From: bill.liderengineering.com
To: [Contact Council](#); [Mead, Jared](#); [Dunn, Megan](#); [Peterson, Strom](#)
Cc: [County Executive](#); bill.liderengineering.com
Subject: July 1, 2025 Planning & Community Development Committee, Table Motion 25-298, Paine Field Westside Aerospace Complex
Date: Monday, June 30, 2025 12:06:35 PM
Attachments: [2025-06-30 Lider Comments on Motion 25-298 SNOCO Planning & Community Development Committee.pdf](#)

SUBJECT: Snohomish County Airport (PAE), Westside Aerospace Complex
Planning and Community Development Committee Meeting, July 1, 2025
Comments of William Lider, PE on Motion 25-298

SUBJECT: Snohomish County Paine Field Airport (PAE)
Westside Aerospace Complex, Water Quality Certification (WQC)
Ecology Aquatics ID Number: 143467
Preliminary Comments of William Lider, PE
Request for Comment Period Time extension

Figure 1: Project location in WRIA 8 is not eligible to use banked wetland credits in WRIA 7 per SCC30.62A.550.2(b).

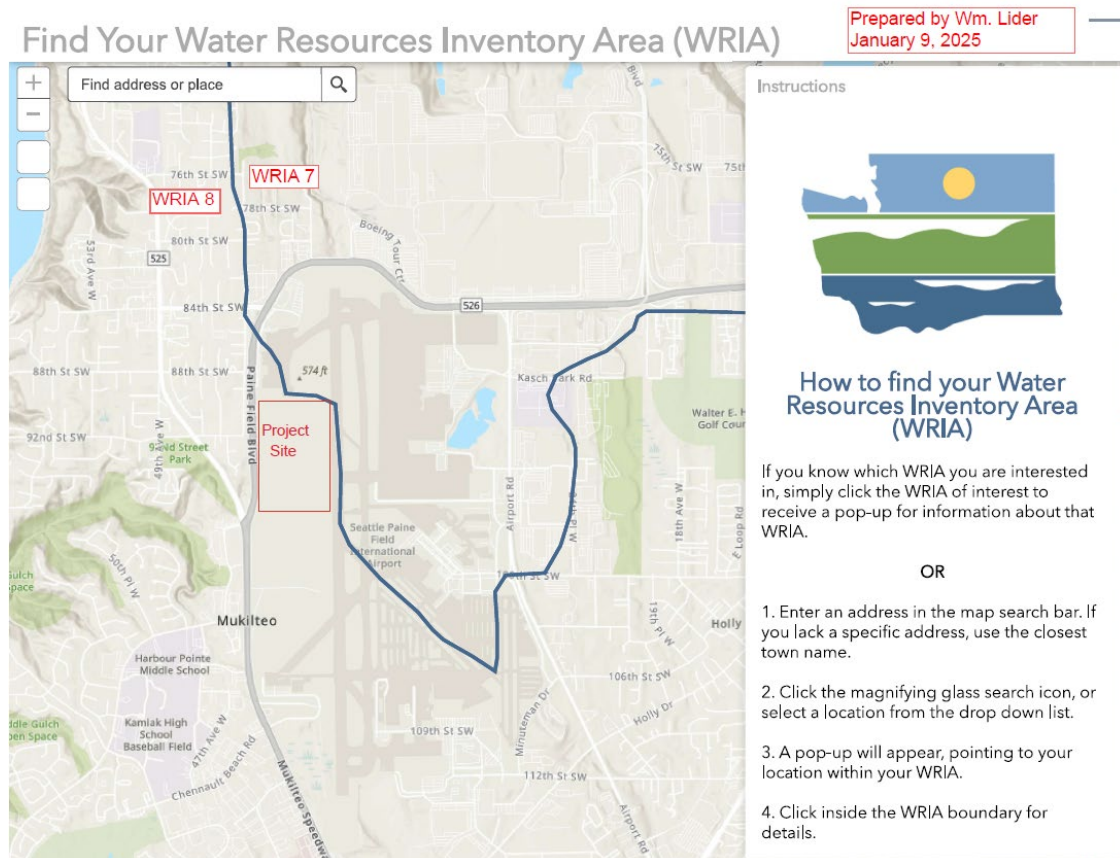
Figure 1 below shows the proposed watershed (WRIA) boundary. The project is mostly in the Big Gulch Creek drainage basin, but also partly in the Smuggler's Gulch Creek drainage too. Both of these drainage basins are in WRIA 8, while the Paine Field Wetland Compensation Bank.

Snohomish County Code explicitly prohibits using mitigation banked credits in a different watershed (WRIA); however, even if the code did allow banked credits in another watershed, it would not provide equivalent mitigation for the threatened species in Big Gulch Creek.

FIGURE 5. PROPOSED DRAINAGE FACILITIES

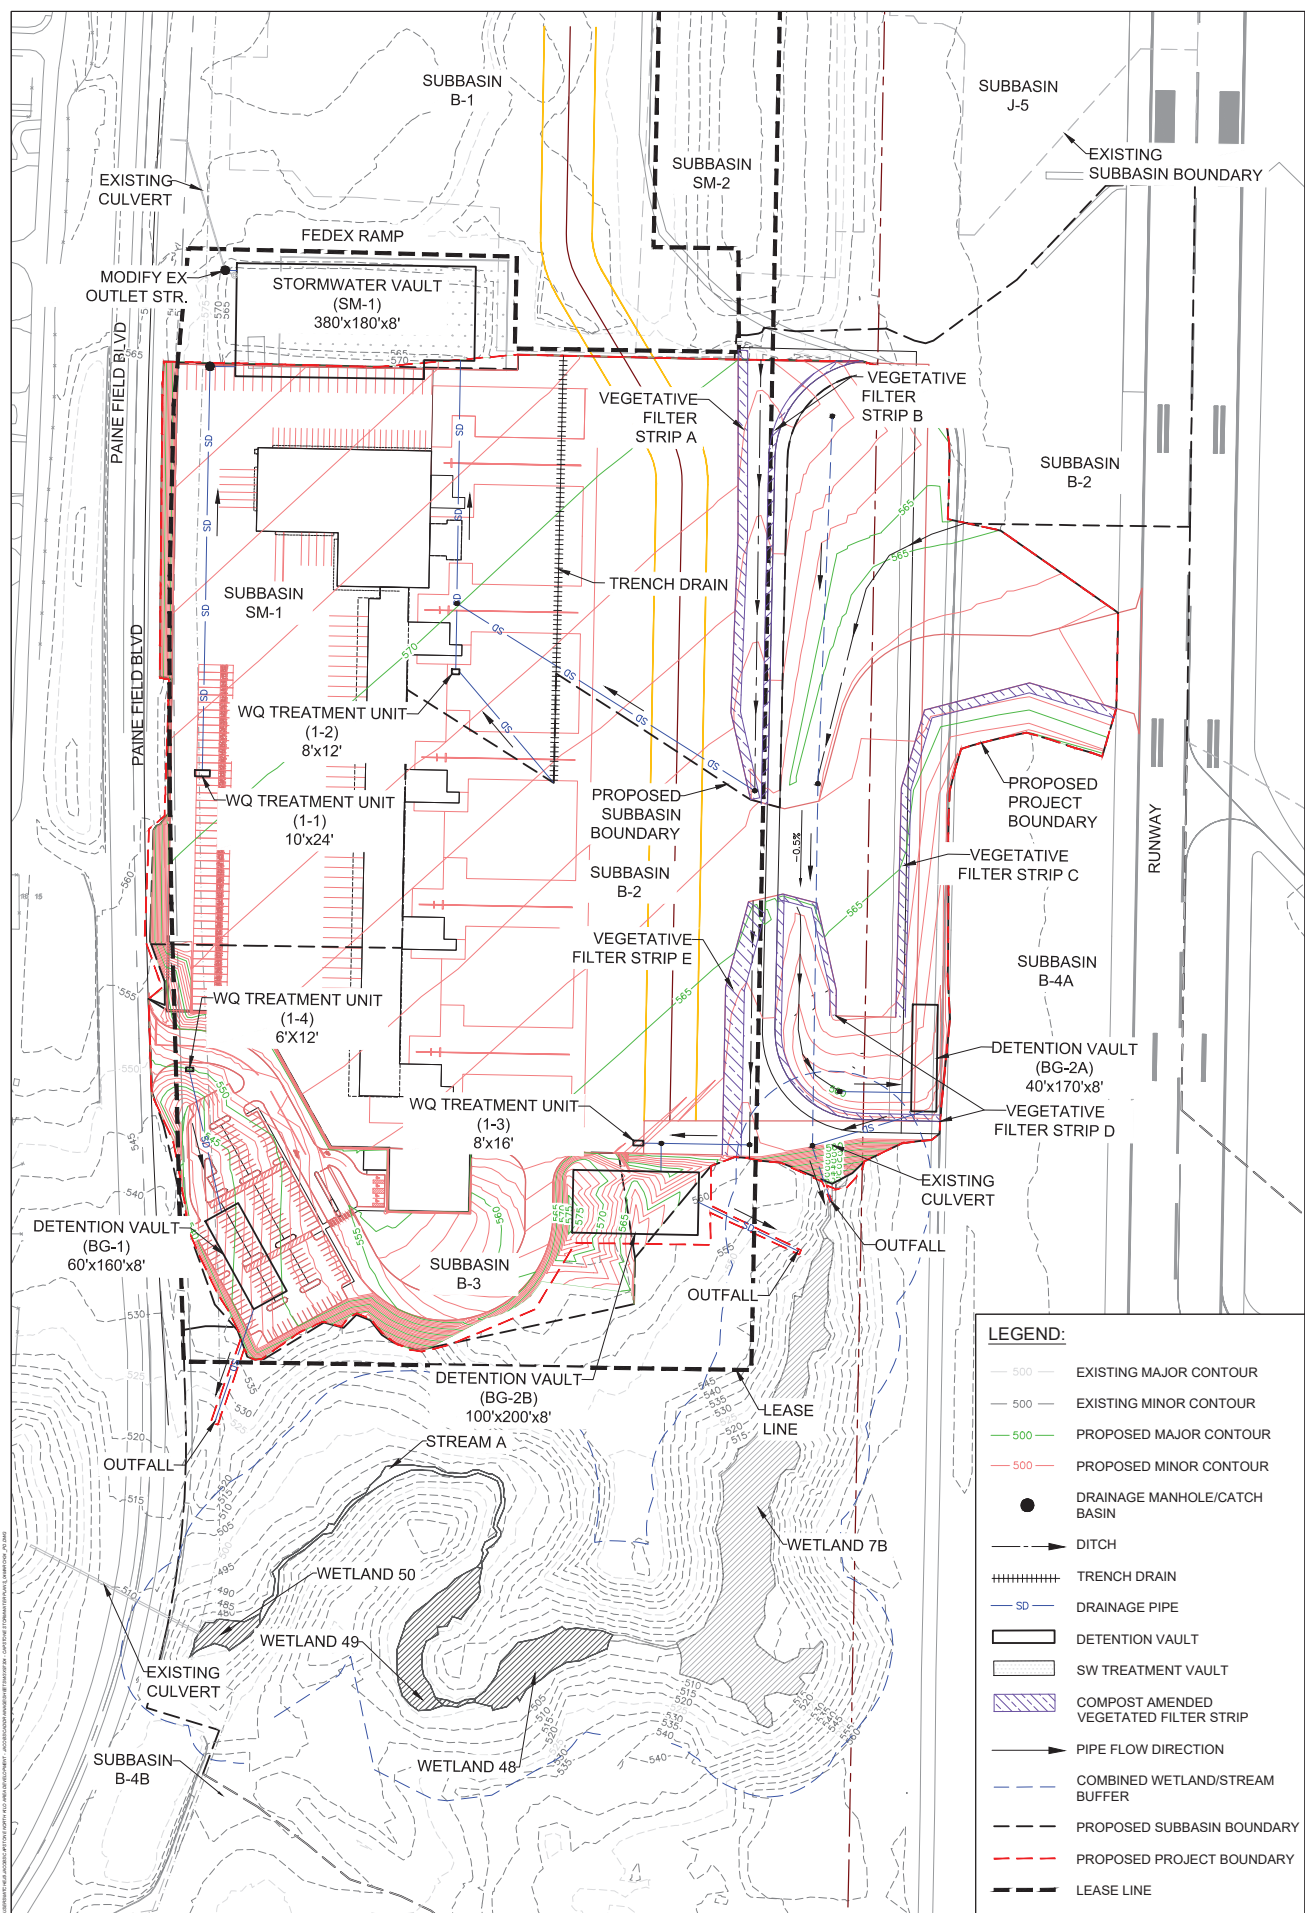
- F. Appendix B, Stormwater Plan, Flow Control Model Output Summary for SM-1, a vault depth as 5.5-feet (active storage 4.5-feet); yet Figure 5, pdf page 74 calls the vault depth out as 8-feet. Correct the WWHM calculations or resolve this ambiguity.

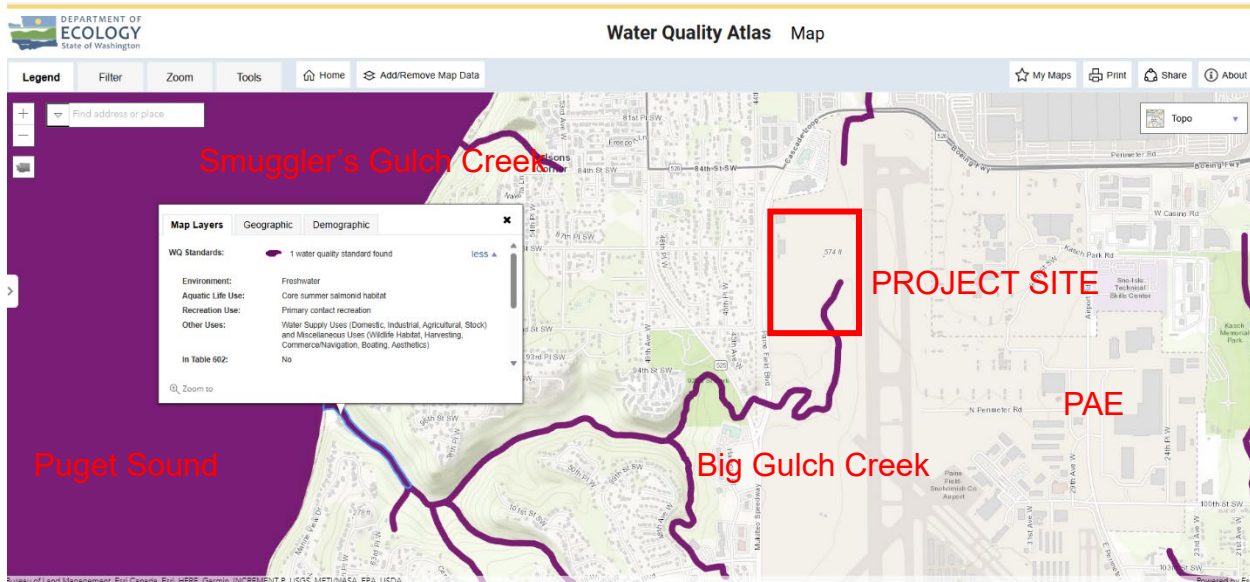
Big Gulch Creek and Smuggler's Gulch Creek both provide core summer salmonid habitat as described in Ecology's Water Quality Atlas² shown if Figure 1 below:

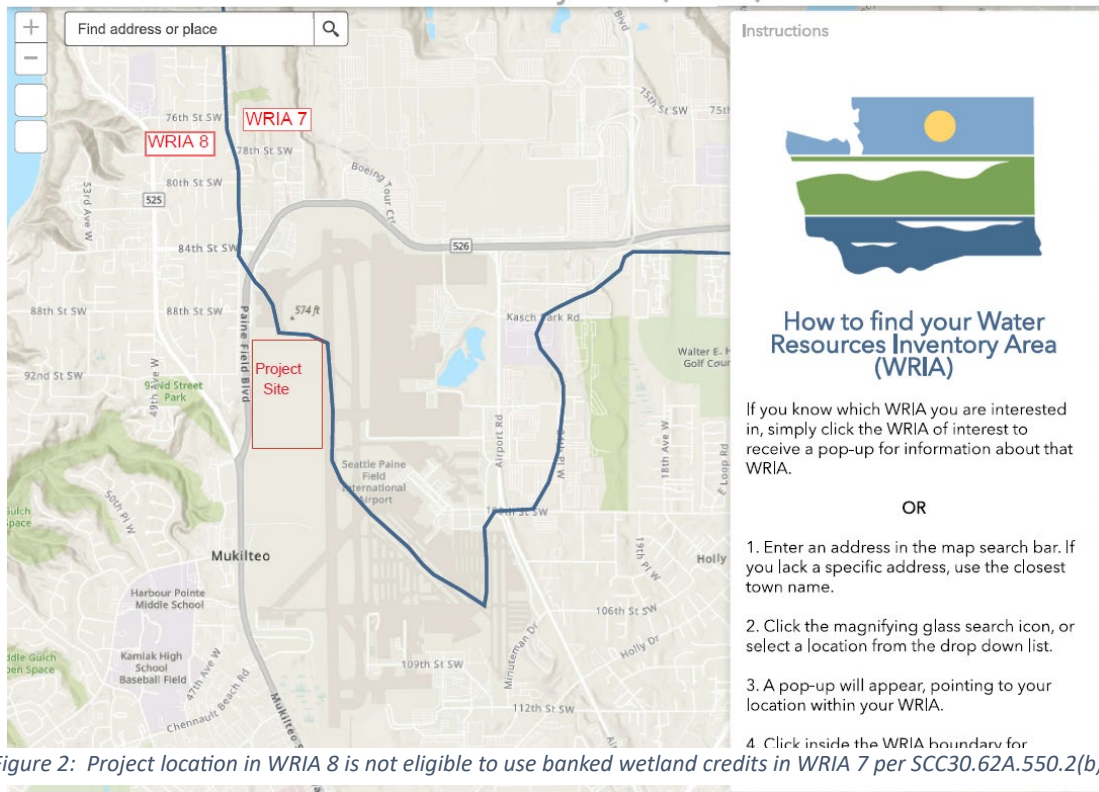
The Figure 2 map³ below shows the proposed watershed (WRIA) boundary at the PAE project site. The project is mostly in the Big Gulch Creek drainage basin, but also partly in the Smuggler's Gulch Creek drainage too. Both of these drainage basins are in WIRA 8, while the Paine Field Wetland Compensation Bank is in WRIA 7.

Snohomish County Code explicitly prohibits using mitigation banked credits in a different watershed (WRIA); however, even if the Snohomish County code did allow banked credits in another watershed, or if Snohomish County were to issue a code waiver, modification, or deviation (WMD) to permit this project, it still would not provide equivalent mitigation for the loss of core salmonid summer habitat for threatened species in Big Gulch Creek.
